**GEORGETOWN-SCOTT COUNTY PLANNING COMMISSION**  
**AGENDA**  
**MAY 15, 2025**  
**6:00 p.m.**

# DUNCAN PROPERTY FINAL SUBDIVISION PLAT

## Staff Report to the Georgetown-Scott County Planning Commission May 12, 2025

**COUNTRY BOY - HI-VIEW  
6325 CINCINNATI PIKE  
PRELIMINARY DEVELOPMENT PLAN**

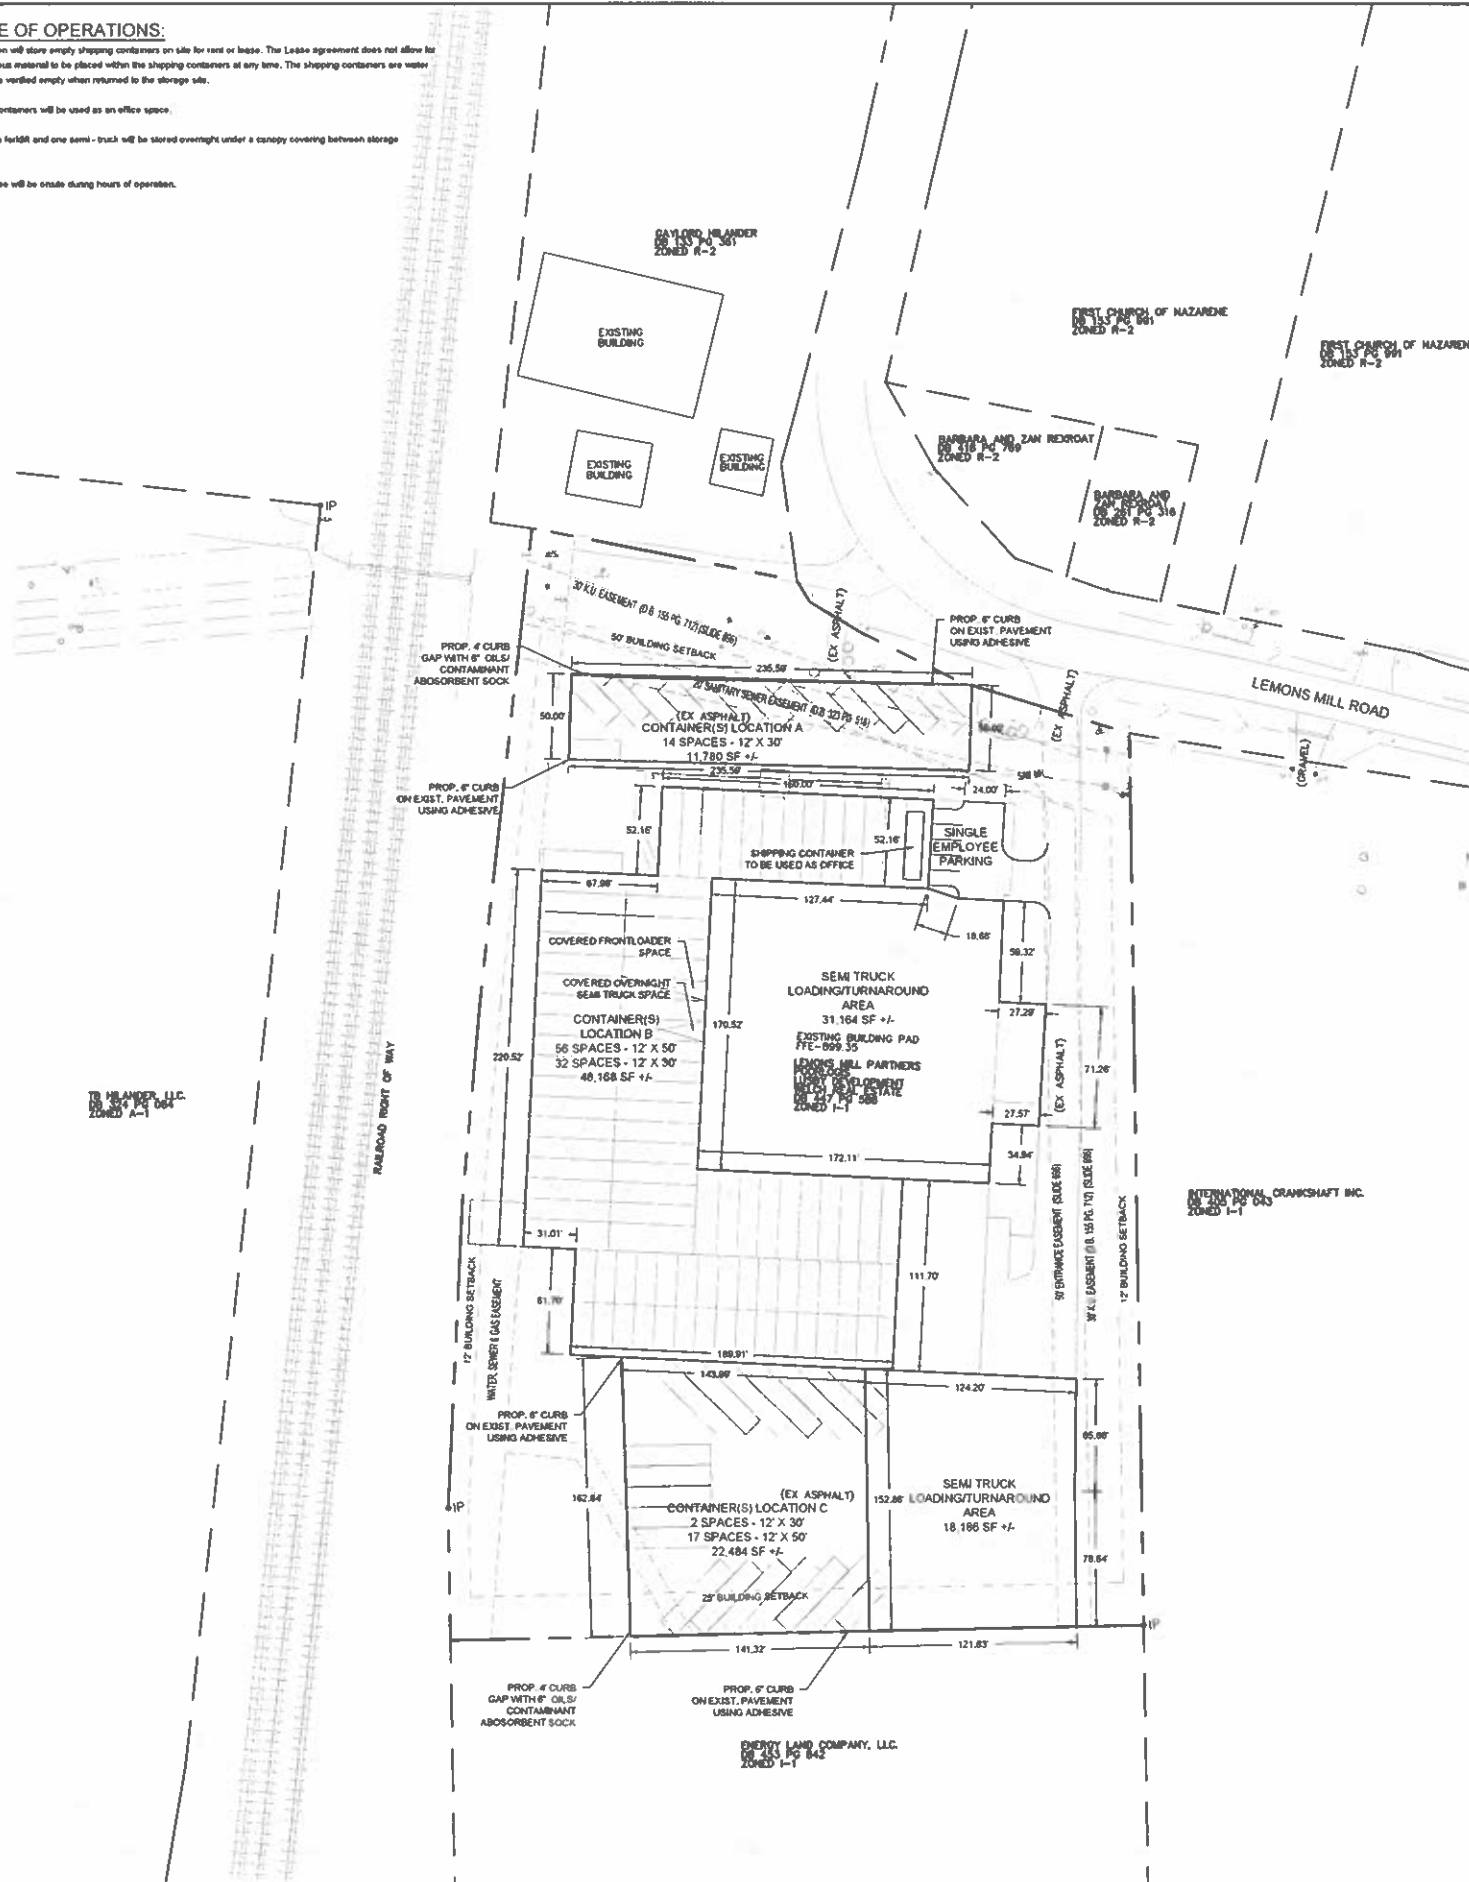
Loading, unloading, and storage areas in an industrial zone are excluded from interior VUA landscaping. The development plan shows 5352 square feet of VUA (parking) that will necessitate landscaped areas. This plan is providing 669 square feet of ILA, to include three (3) trees.

This site is located within the Royal Springs Aquifer Recharge area, and the development has been reviewed by the Wellhead Protection Committee for recommendation to the Planning Commission. This committee has approved this development and has given requirements that are noted on the site plan.

8. A species-specific landscape plan shall be included with the Final Development Plan indicating all trees to be preserved during construction.
9. All requirements of the Georgetown Fire Department regarding fire hydrant locations and emergency vehicle accessibility.

JOB NUMBER: 12184.00  
SHEET: C-1.0

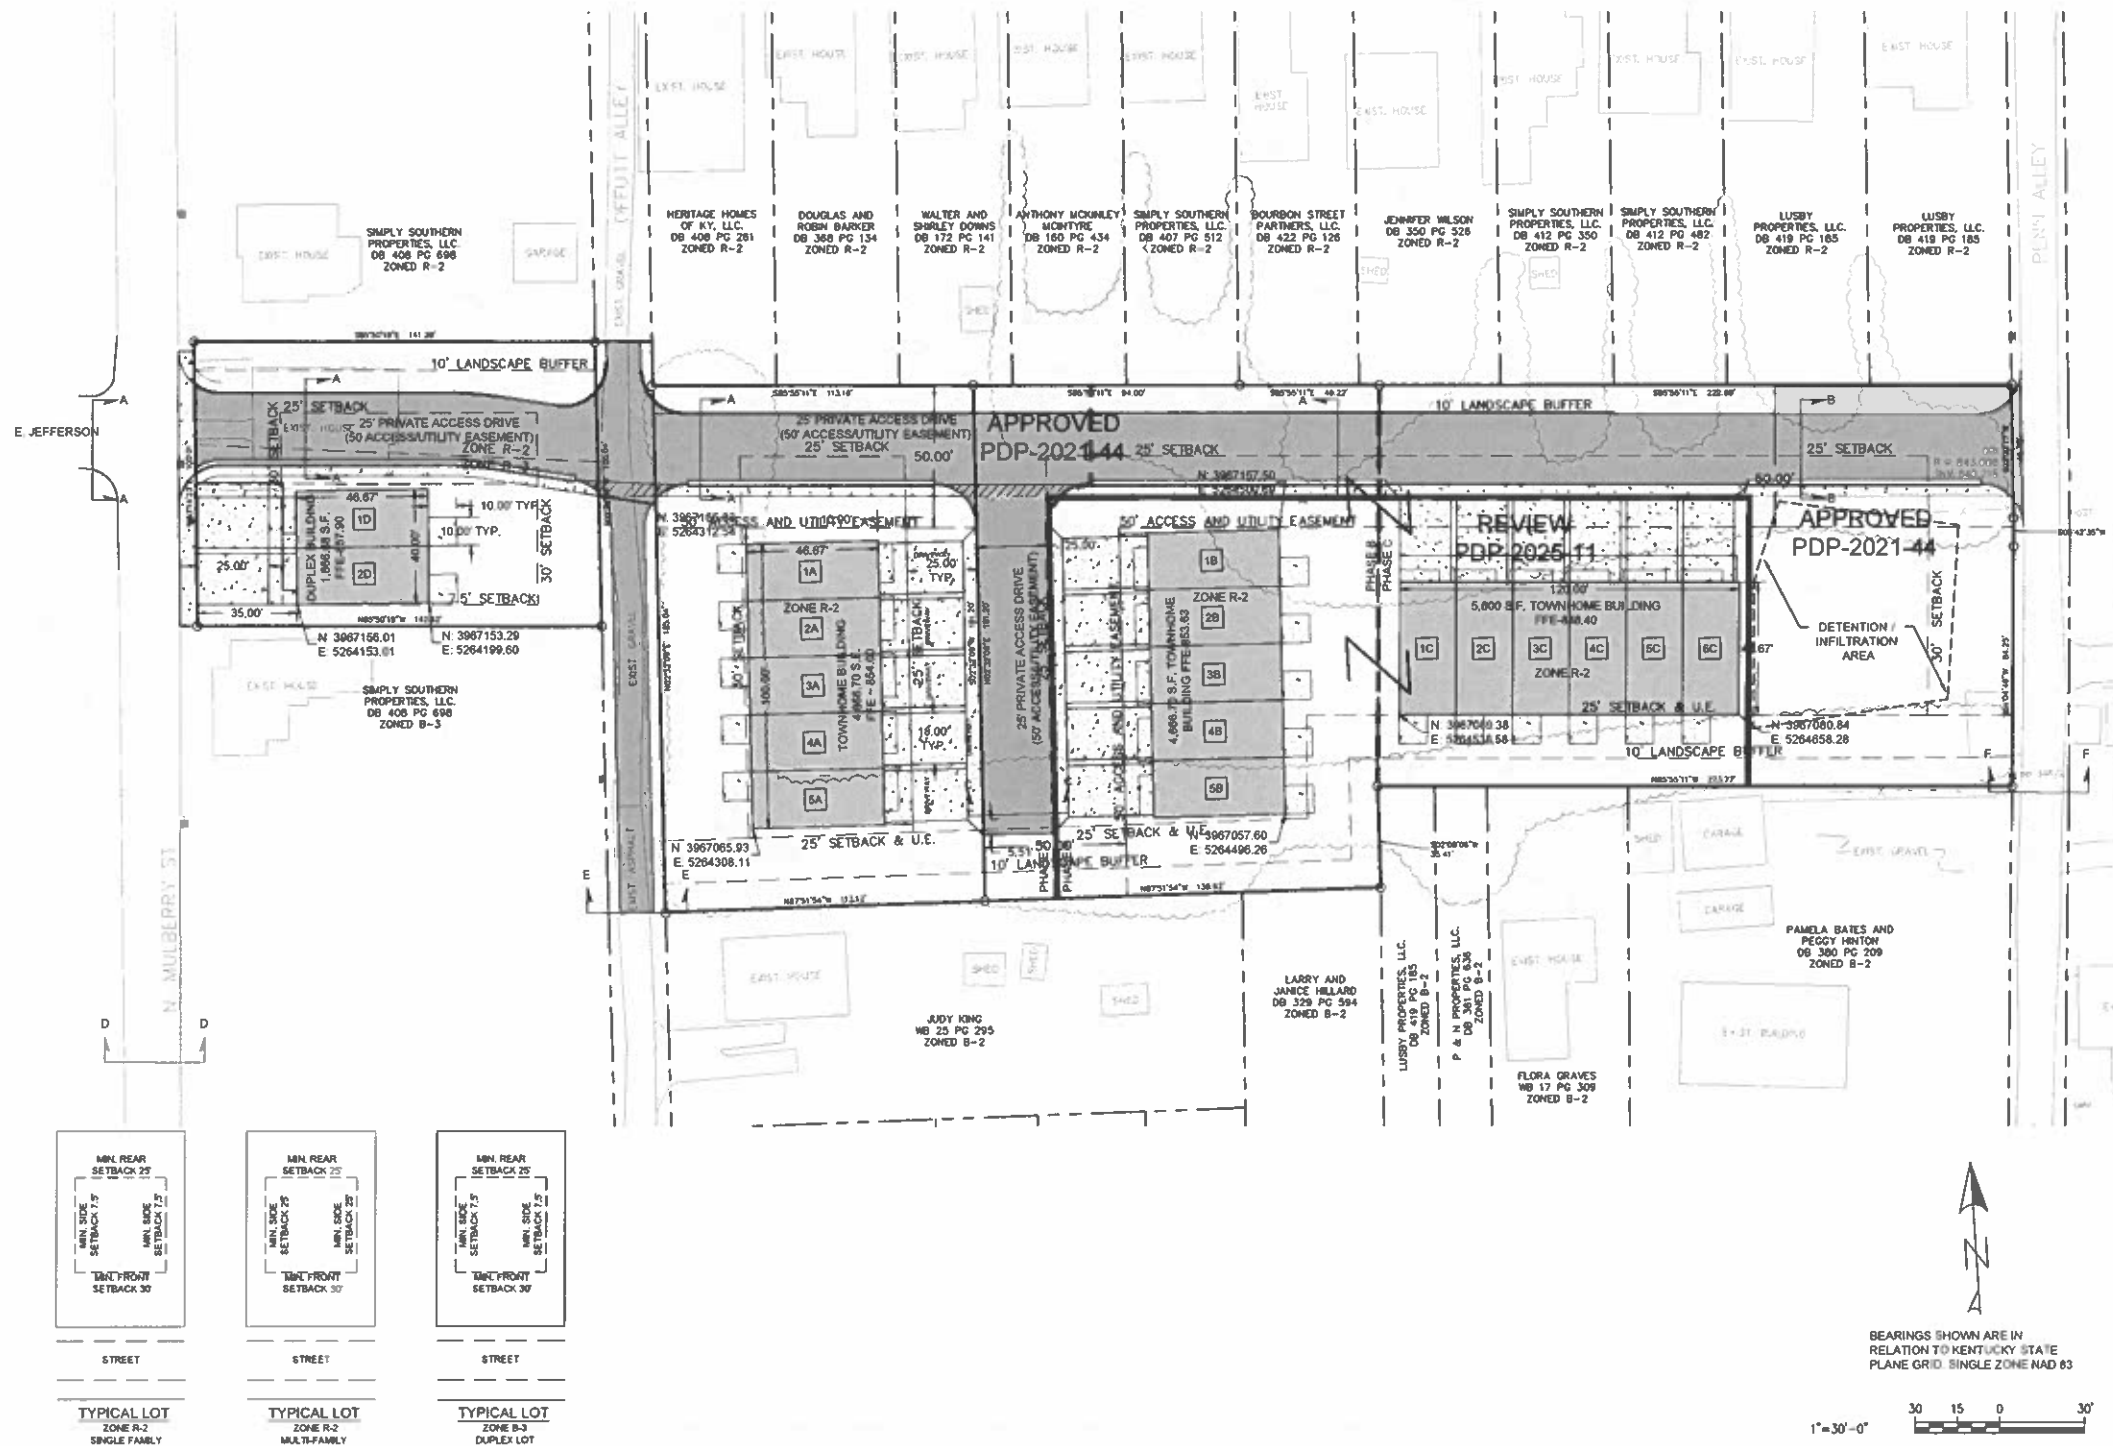
Per the *Subdivision & Development Regulations*, each 2-bedroom townhome units shall have 2.5 off-street parking spaces available, or in this instance 28 total parking spaces. The preliminary development plan shows 33 parking spaces, or 3 per unit. Each unit will have an attached one car garage and a 12.5-foot by 25-foot driveway/parking pad for personal vehicle use. The *Subdivision & Development Regulations* states that a road must be 26-foot-wide at minimum to allow for street parking on one side, so street parking is prohibited.

The preliminary development plan would have pedestrian access through an already approved and constructed sidewalk located along the south side of the proposed private drive. This sidewalk along the private drive should be connected to the sidewalk between the driveways and the townhomes. This would allow for pedestrian access to the proposed townhome units and connect them to the existing pedestrian network of the surrounding neighborhood.

The *Landscape & Land Use Buffers Ordinance* requires a 3 to 5-foot-wide buffer area between a vehicular use area (VUA) and either any property in any zone or an adjoining public or private street, right-of-way, access road or service road, and for those areas to be populated with 1 medium or large tree per 40 feet of linear boundary plus a 3-foot-tall continuous buffer. This is required along the north and south boundaries of the private access easement. In instances where two buffering requirements overlap, the stricter of the two requirements should be observed. The final landscape plan will need to reflect this requirement.
